## DELEGATED APPLICATION REPORT

**Address:** 220 Elgar Road South, Reading, RG2 0BW

**Application No:** PL/25/1189

**Proposal:** Non-material amendments to permission 220258 (allowed on appeal [APP/E0345/W/23/3315618] on 02/04/2024 for 'a residential redevelopment comprising demolition of existing single storey building and erection of 16 dwellings together with associated works-revised scheme following the refusal of application 210526') to alter the wording of conditions 2 (approved plans) and 9 (amenity space) to reflect changes to the approved plans, including: omission of an oriel window on the north elevation at first and second floor level and replacement with north facing windows; omission of a window on the west elevation at first floor level and east elevation at second floor mezzanine level, both with replacement brickwork (amended description).

Allowed on appeal (left) and as now proposed (right) west elevation plans

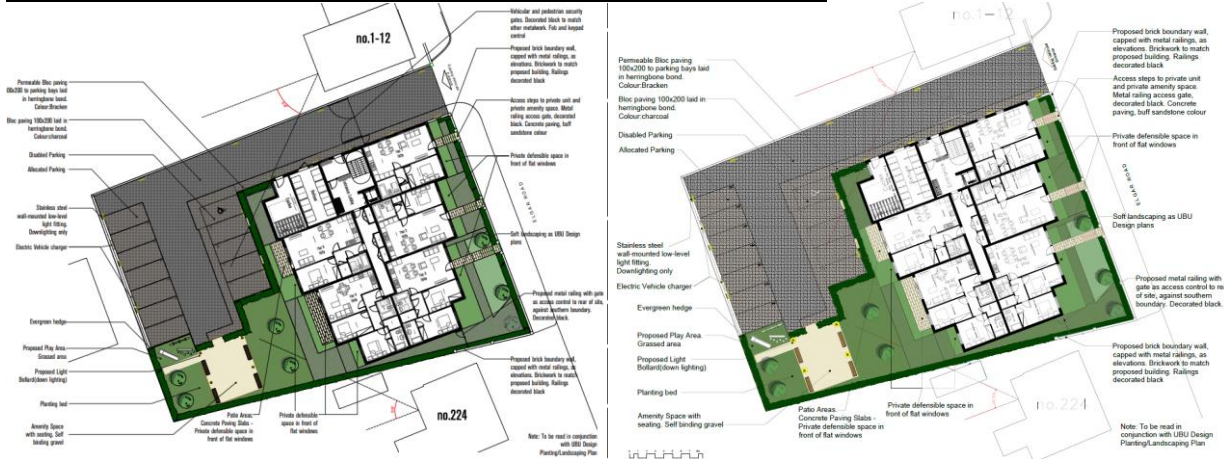
### 3) Omission of a window on the west elevation at first floor level

This window has been “deemed unnecessary by our Client”, according to the supporting information provided by the applicant.

The window to be omitted served an en-suite bathroom to the master bedroom within Flat 8. It was a high-level window only, as shown on the elevation plan. Whilst windows within bathrooms are considered to be preferable from a quality of accommodation perspective, they are not essential features and do not significantly worsen the overall standard of accommodation for future occupiers. No amenity impacts on neighbouring occupiers are envisaged and from a design perspective, the brickwork will match that existing at this part of the building. As such, this change raises no issues.

Allowed on appeal (left) and as now proposed (right) proposed site plans

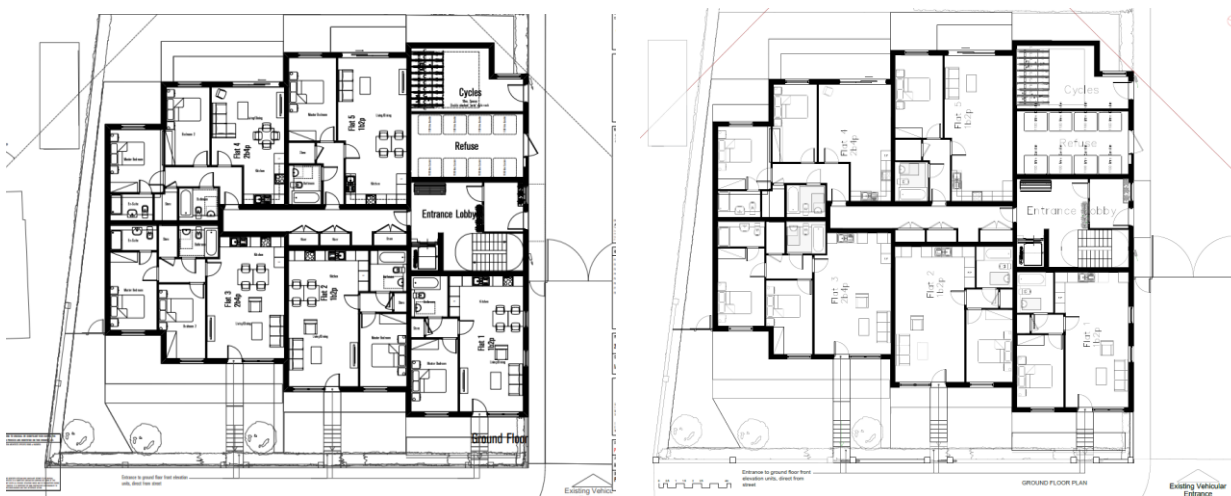
To facilitate these changes, it is proposed for the wording of condition 2 (approved plans) to be altered, to reference the now submitted plans. Given the site plan is referenced in condition 9, the wording of this condition is proposed to be altered too to reflect this.

Allowed on appeal (left) and as now proposed (right) second floor mezzanine level plans

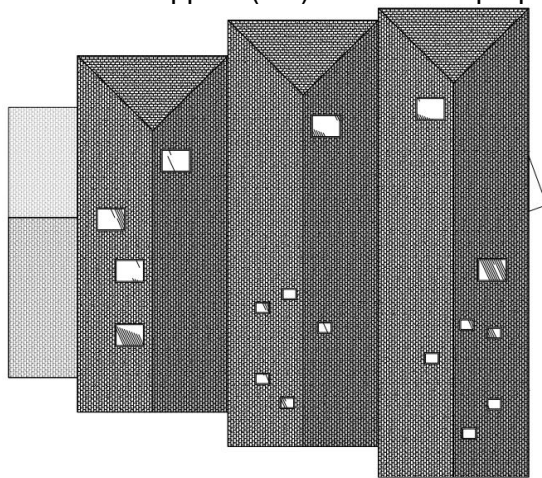
- 2) Omission of a window on the east elevation at second floor mezzanine level and replacement with brickwork to match that already surrounding it

This proposed change will omit a single window in the upper level of a double height living/dining/kitchen room within Flat 14. Replacement brickwork, matching that of the approved surroundings, will be provided instead. From a quality of accommodation perspective, this will reduce the amount of natural light within this room, but ample light will continue to be provided through other windows within this room. From a maintenance perspective, the non-provision of a window will be easier for future occupiers. In terms of amenity impacts on nearby occupiers, no adverse impacts are envisaged. In respect of the knock-on design implications, it is acknowledged that the omission of a high level window does reduce the irregular symmetry that the allowed on appeal scheme created, with a window within one half of each of the three gables. As such, some of the distinctiveness of the original design would be reduced by the proposed change. However, in relation to the design idiom of the scheme as a whole, this represents an inconsequential change and does not significantly undermine the original design intent of the scheme. Unlike the other two windows at this part of the building, the internal space does not serve single level spaces, so the non-provision of a window at this point could be considered to actually assist legibility. In summary, this change is considered to be non-material in the context of the overall scheme from both amenity and design perspectives.
